## SPC58xCx - cut2.0 changes vs cut1.1

This technical note describes all the changes implemented in the SPC58xCx cut2.0 with respect to the cut1.1.

Figure 2. Pad keeper configuration

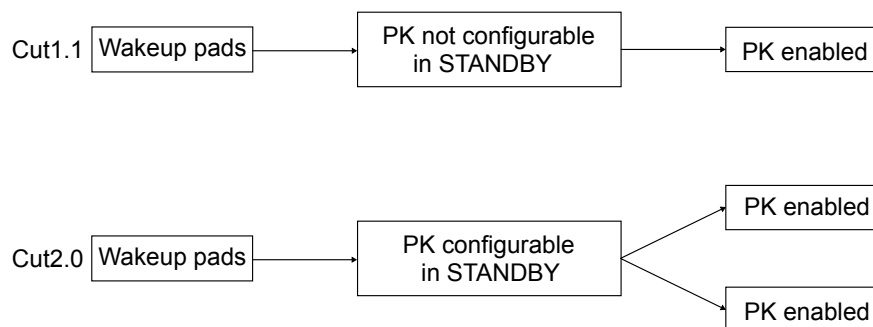
As PK (pad keeper), applying an internal pull (up/down), modifies the impedance of the input, some application signals need extra external components to cope with the PK.

For such reason, PK feature has been made configurable by software on cut2.0 for all WKUP pads.

For the non-WKUP pads (OPCs/PDCs/TDO), PK feature cannot be configured and it will be enabled immediately at STANDBY mode entry.

On cut2.0, PK configuration is done through the WKPU.WIPUER register:

- WIPUER[X] = 0 (default) → PK enabled
- WIPUER[X] = 1 → PK disabled, pad in HiZ during STANDBY
